# City of Alexandria, Virginia

## MEMORANDUM

**SUBJECT:** WORK SESSION COMMENTS ON 220 SOUTH UNION STREET  
BAR CASE #2014-0037 and 2013-0321

## Gable and chimney at the Strand

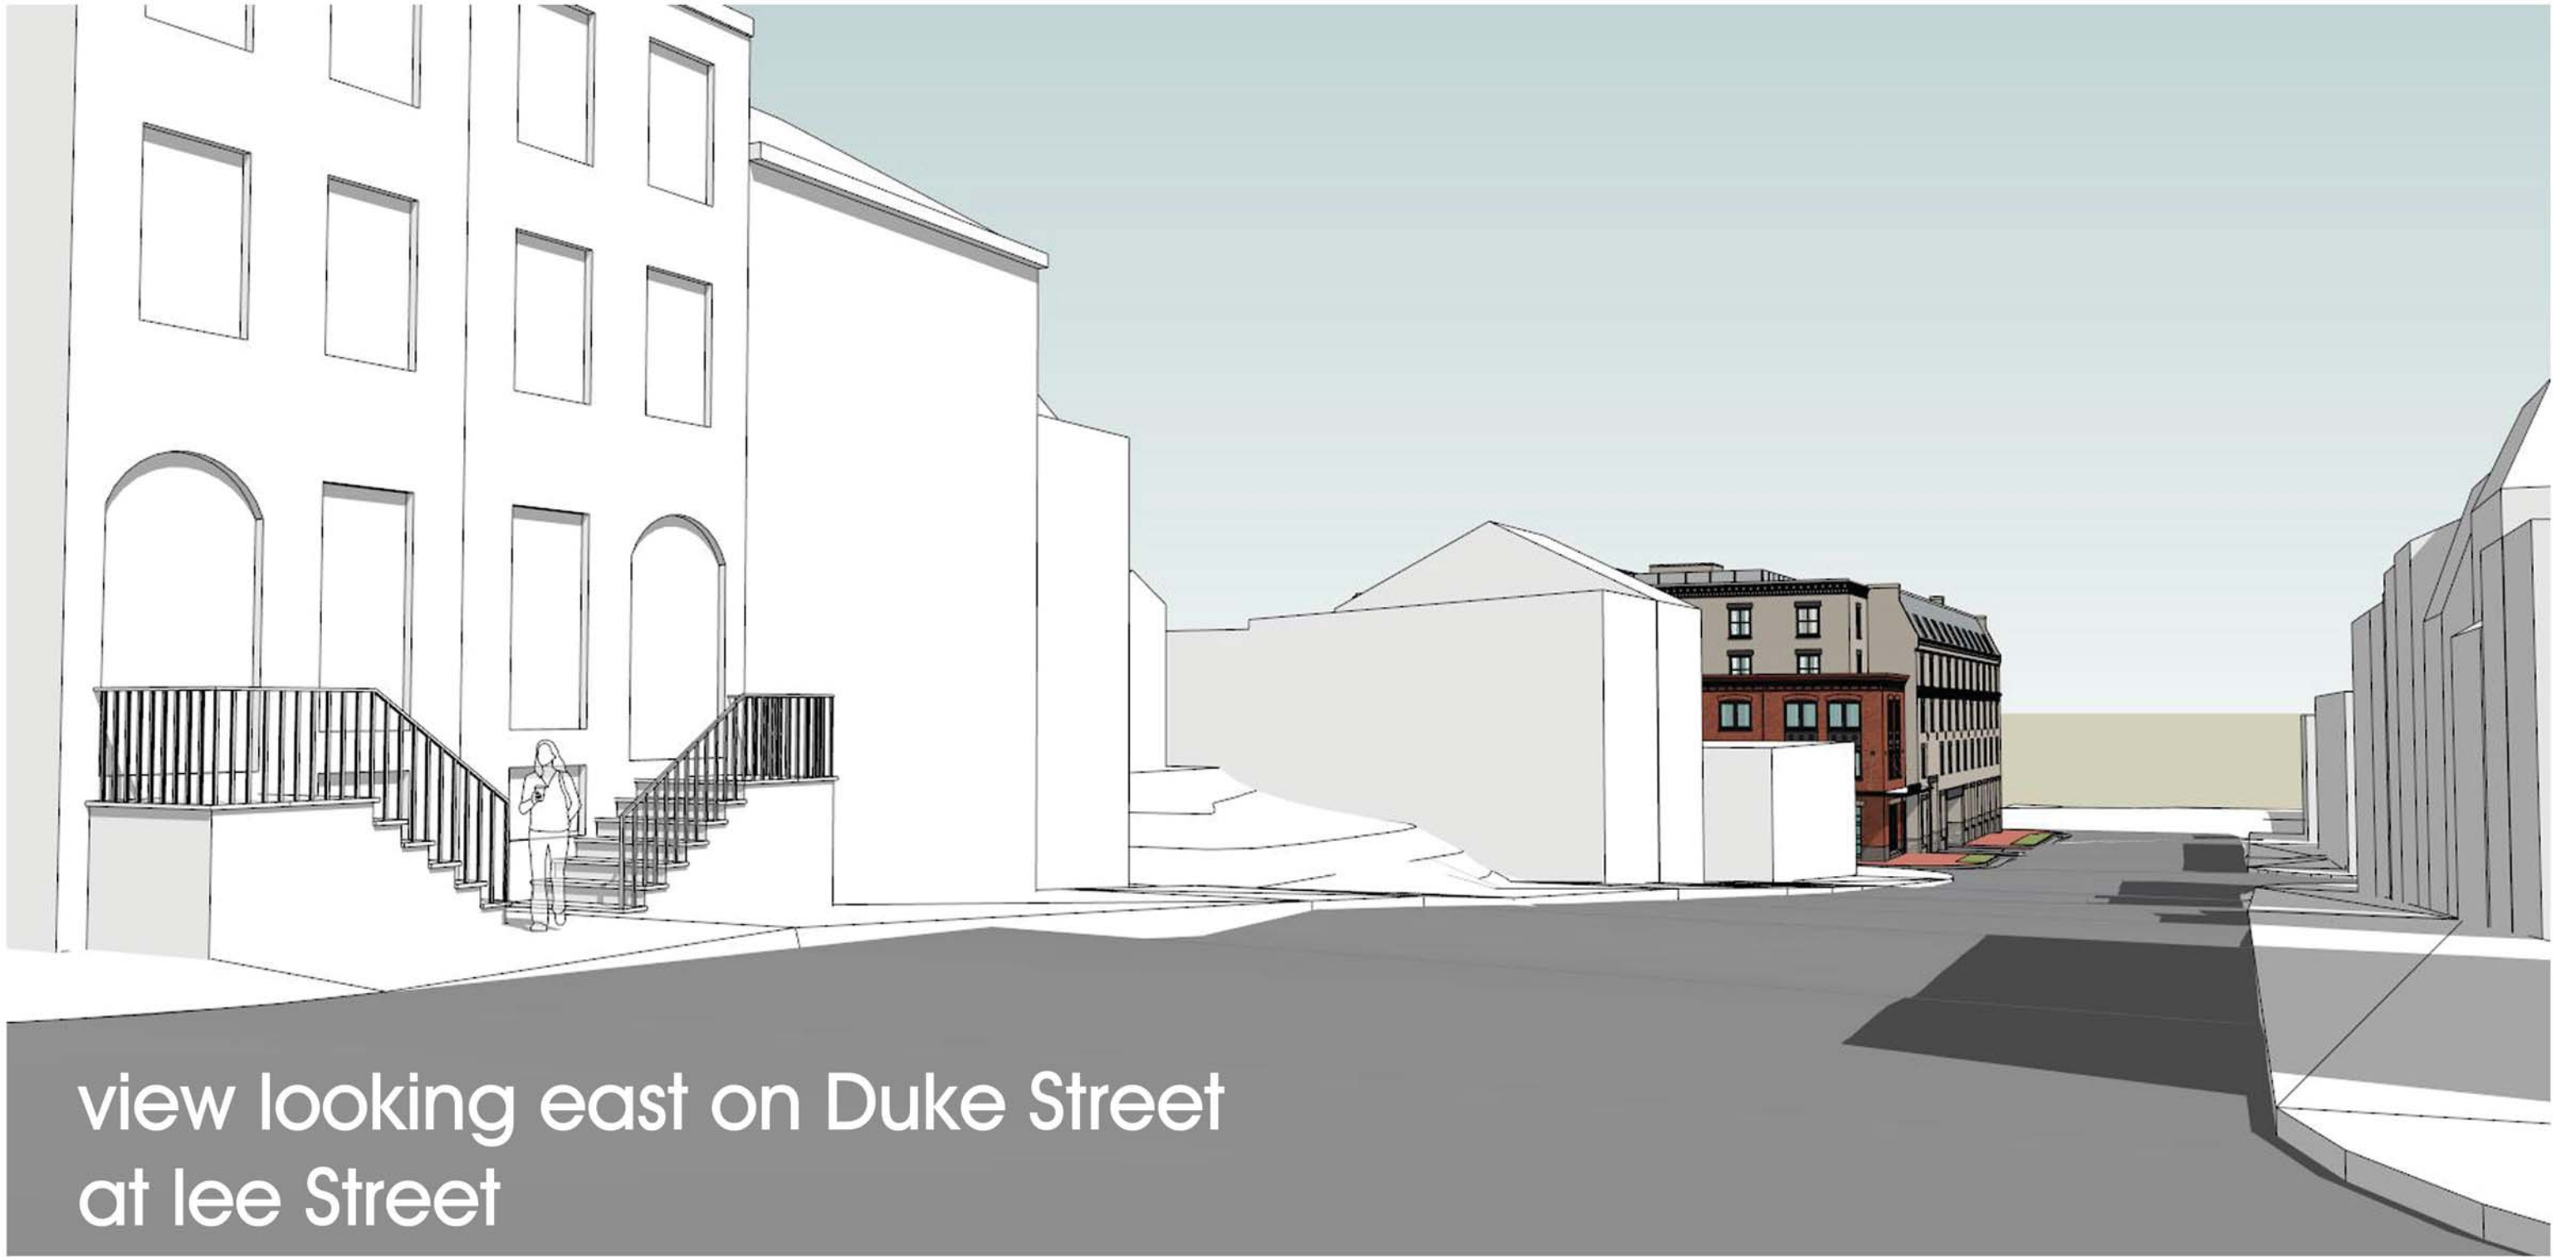
The applicant has provided perspectives showing that the recommended west gable end would only be minimally visible to pedestrians from the Duke and Lee Street intersection a block away and may not read coherently with the rest of that portion of the building. However, the rooftop mechanical equipment still must be screened with material that is equal in quality to the building

wall. The applicant has, therefore, suggested, and staff supports, extending the brick wall of the elevator penthouse. The applicant has also represented that the rooftop equipment has been gathered in the center of the roof and will not be visible to pedestrians from any other locations. The Board may, therefore, consider waiving the rooftop mechanical equipment screening. The gable on the Strand elevation will be functional screening and the framing behind that roof will be further studied by the applicant.

**Current Recommendation: That the Board evaluate the option of an expanded elevator penthouse as rooftop mechanical screening and the potential for waiving a portion of the rooftop mechanical screening at the work session.**

add matching gable end to west side of building #2

alternate elevation #1

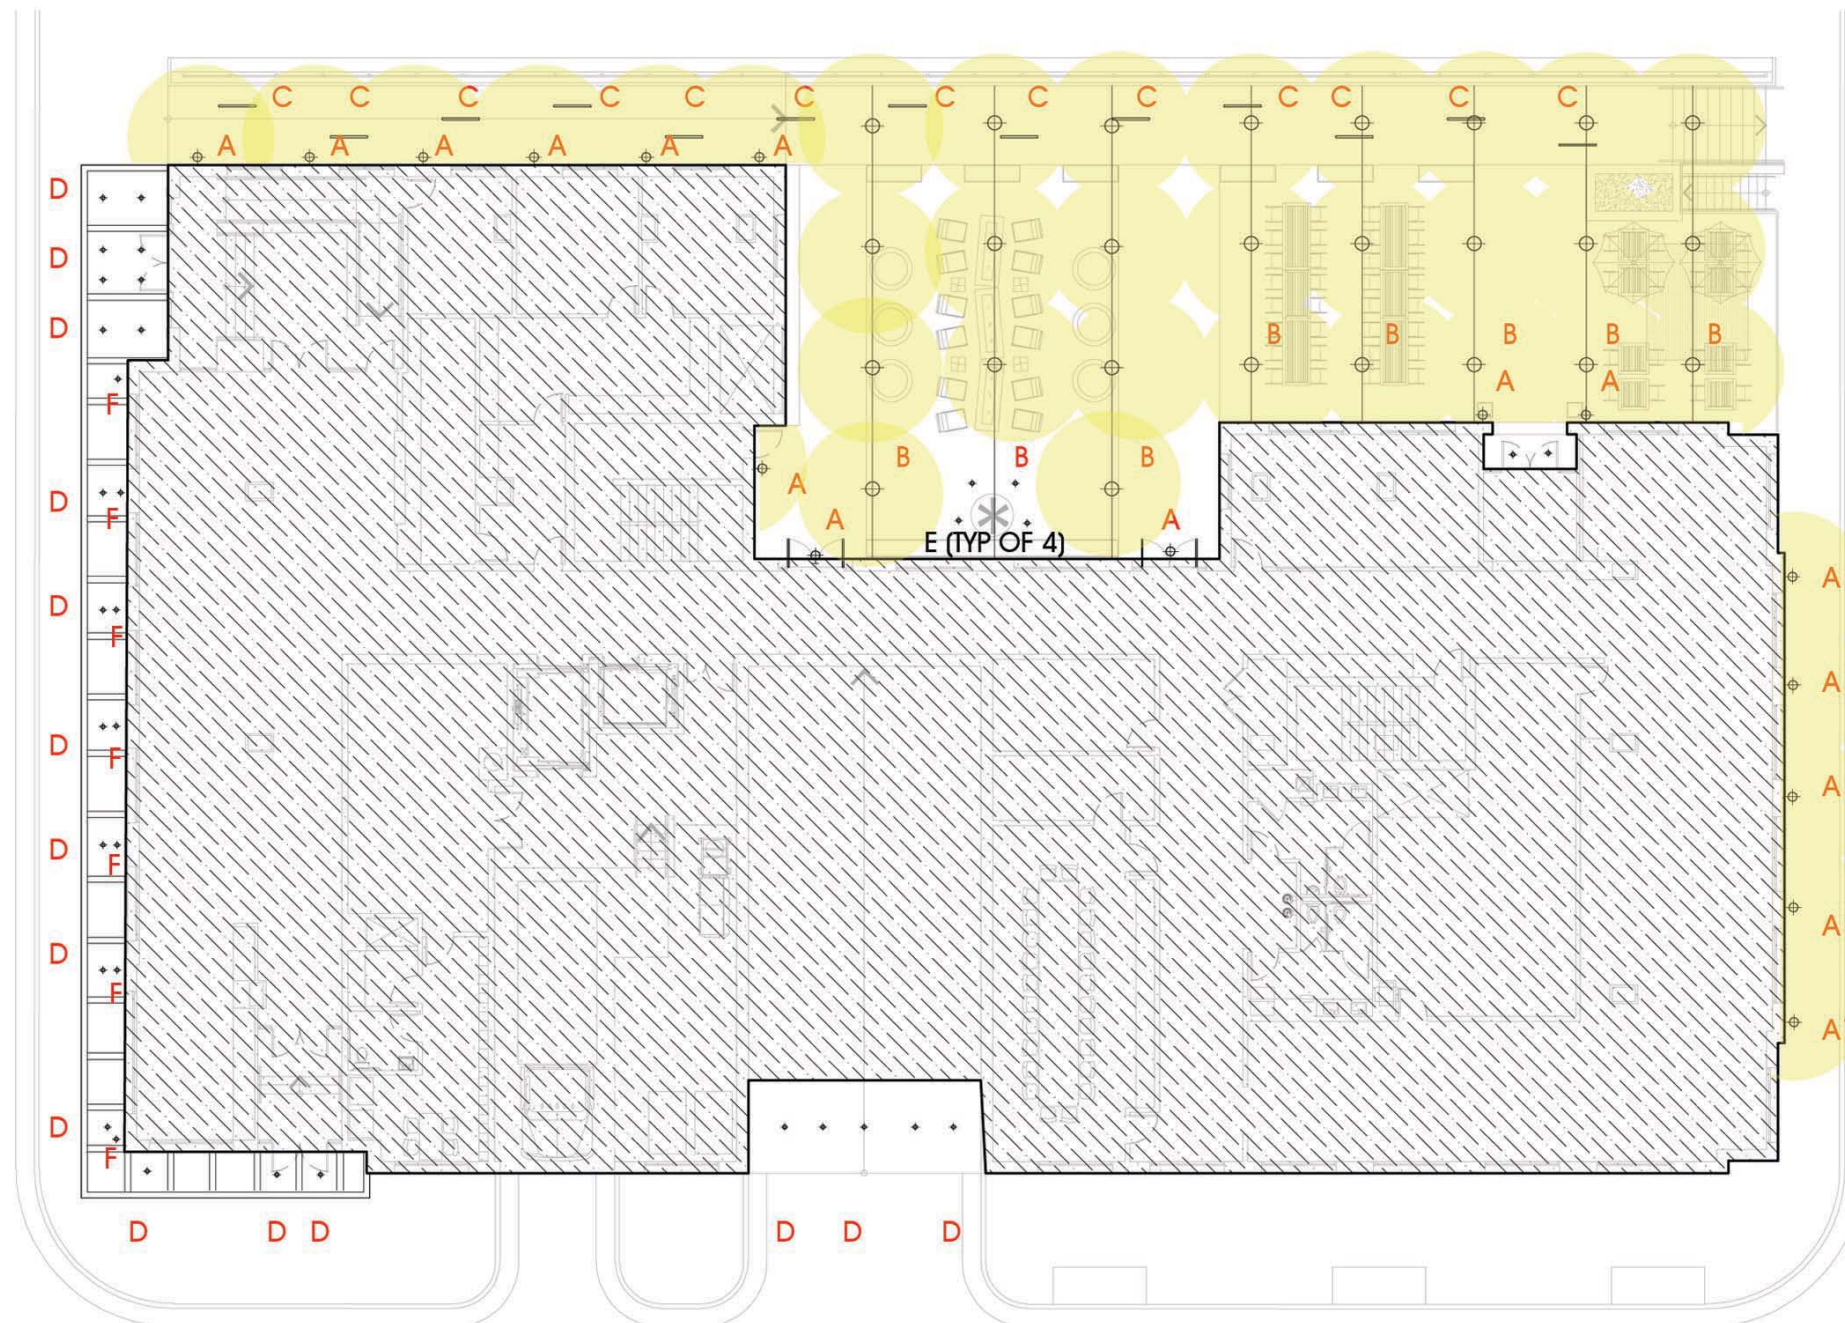
**Staff Report Recommendation #4:** *That The Strand elevation be refined, as it will be the most prominent elevation—eliminate the spandrel panels and explore the use of French doors and shallow balconies to create an architectural dialogue with the waterfront parks.*

The applicant prepared three studies of this elevation and removed the spandrels. Staff strongly supports removal of the spandrel panels. The inclusion of French doors on this elevation provide for a much stronger connection with the future waterfront park. Staff supports either glass or metal railings but believes the metal railings more successfully reflect a contemporary version of the 18<sup>th</sup> century wheat sheaf porch railings found in Old Town.

**Current Recommendation: French doors with iron railings on The Strand elevation**

ROOF PLAN

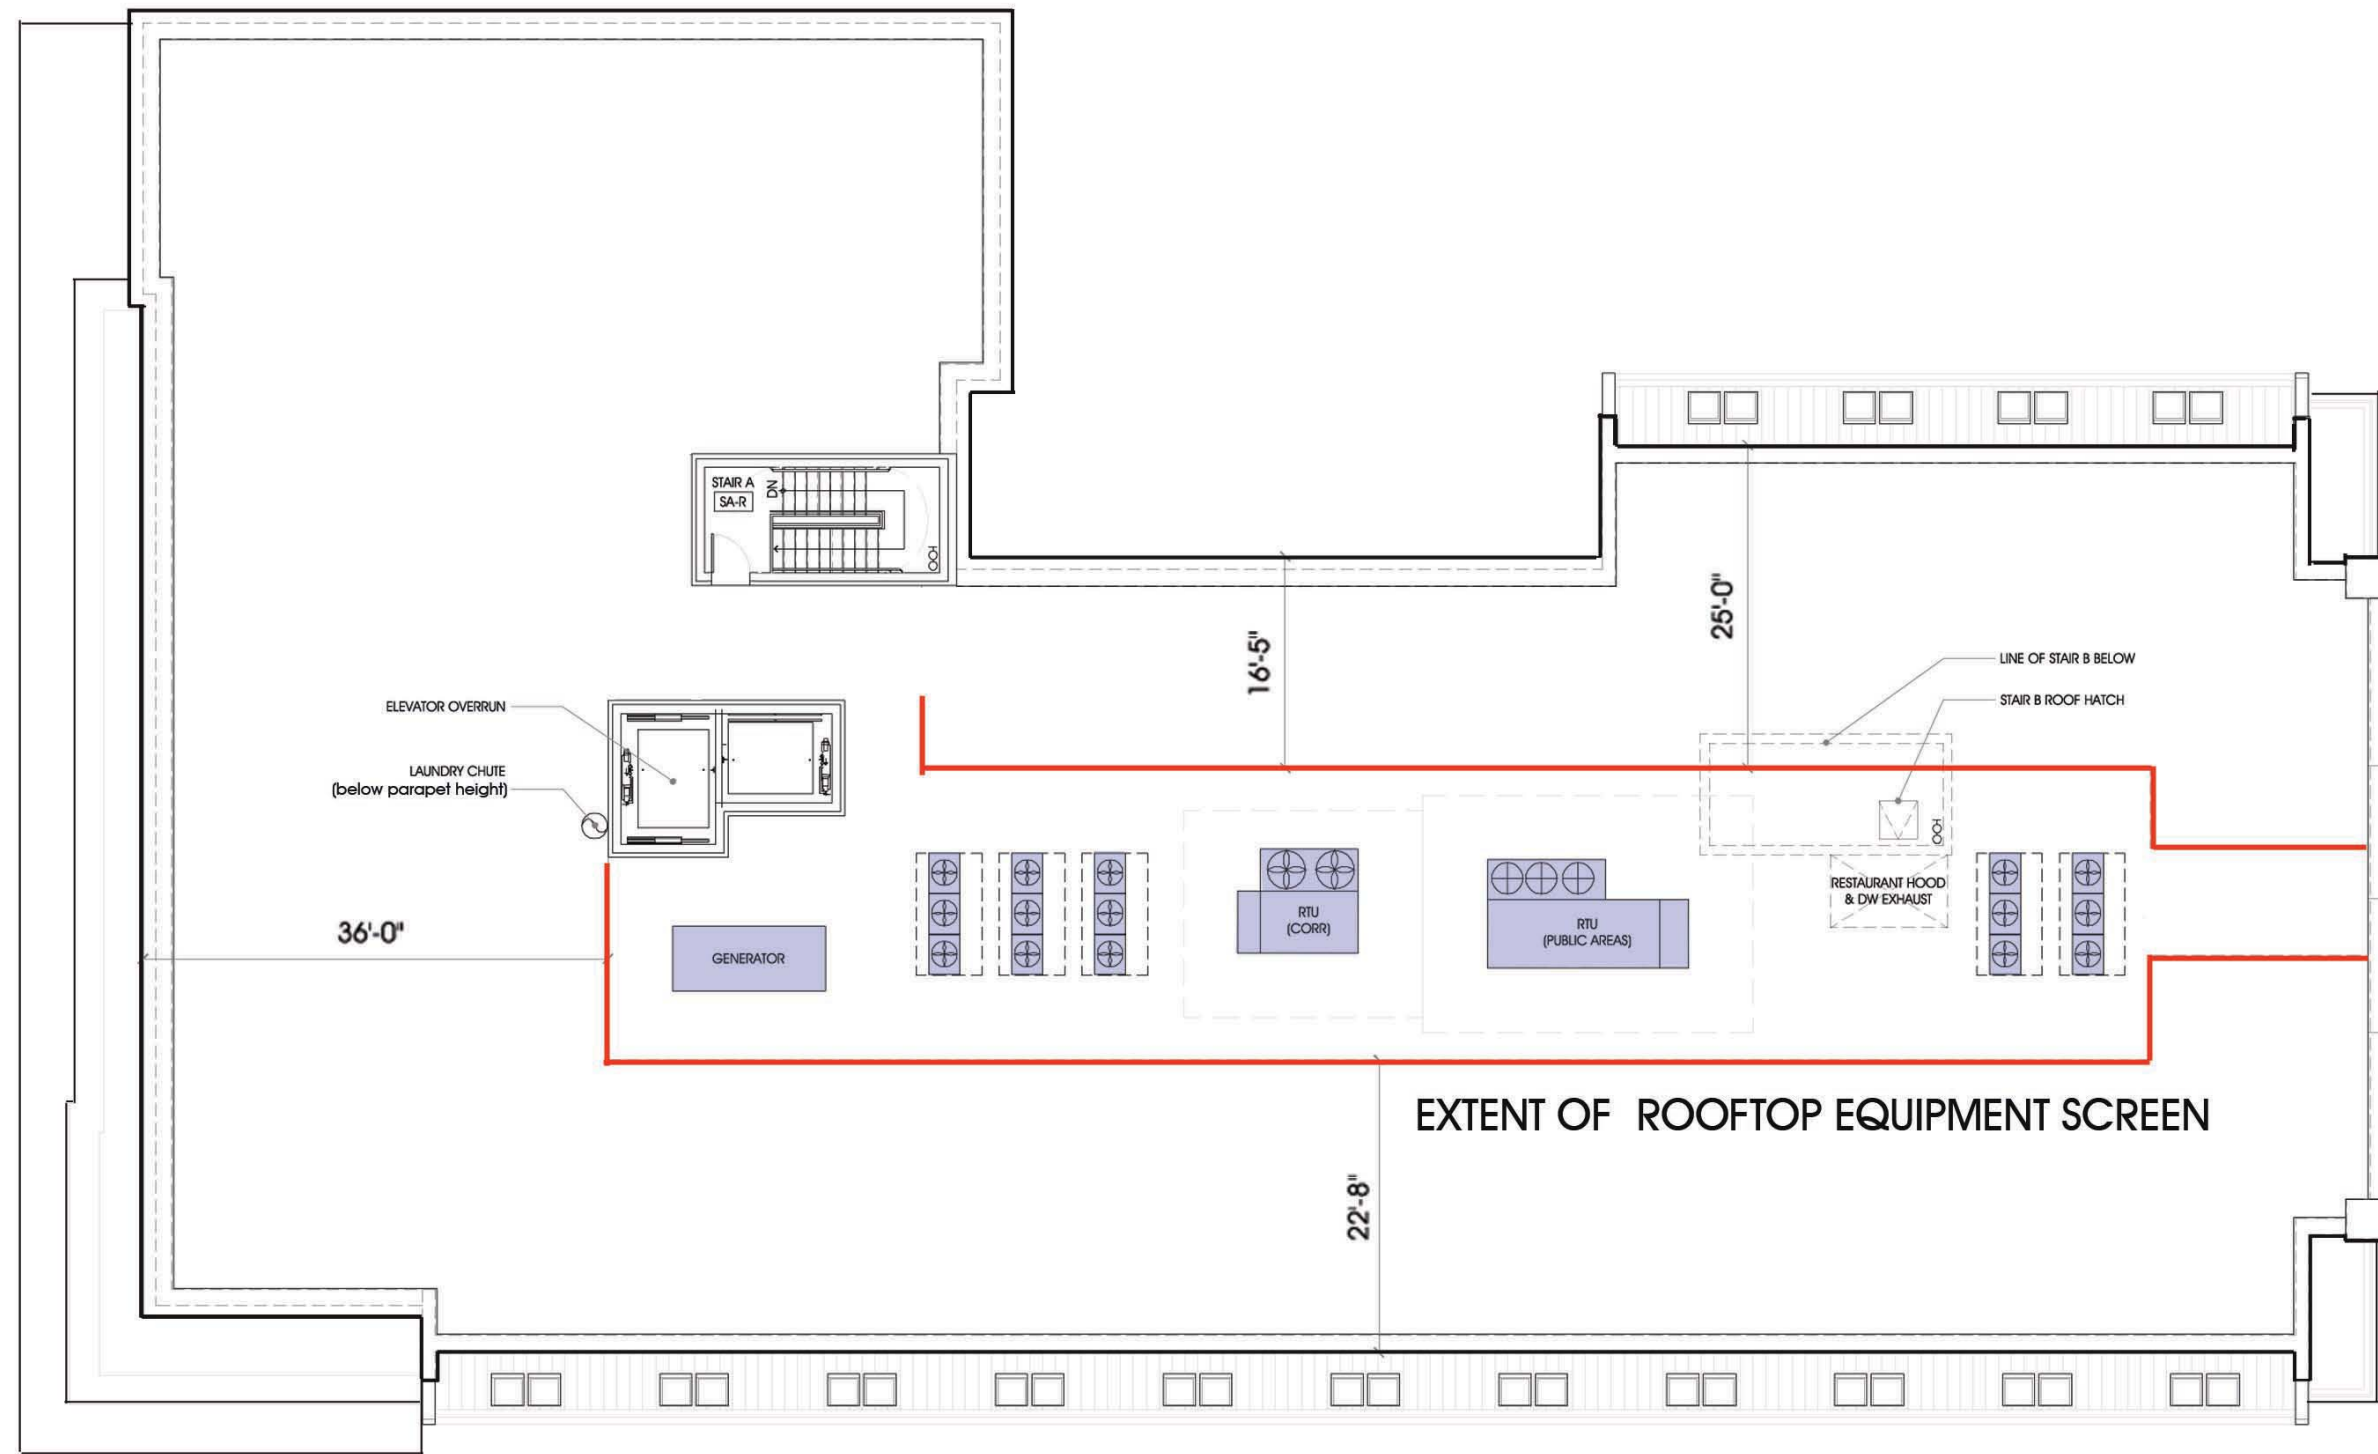
**Staff Report Recommendation #9:** *That the applicant provide a roof plan locating all mechanical equipment, illustrating how any rooftop projections above 50 feet function as chimneys and equipment screening with architectural quality equal to the building walls below. Continue to study and architecturally integrate the proposed HVAC screening.*

As described in Recommendation #1, the applicant has refined the roof plan and the area proposed for penthouses and mechanical equipment has been reduced and located in the center of the roof. Additional details on equipment size must be provided to confirm public visibility. Staff believes there is an opportunity to further study the rooftop screening to minimize the screening. For example, expansion of the elevator penthouse brick wall on the west end and a framed structure behind the east end gable can sufficiently serve as screening.

**Current Recommendation: Continue to study rooftop HVAC placement and provide high quality screening or waive screening where appropriate.**
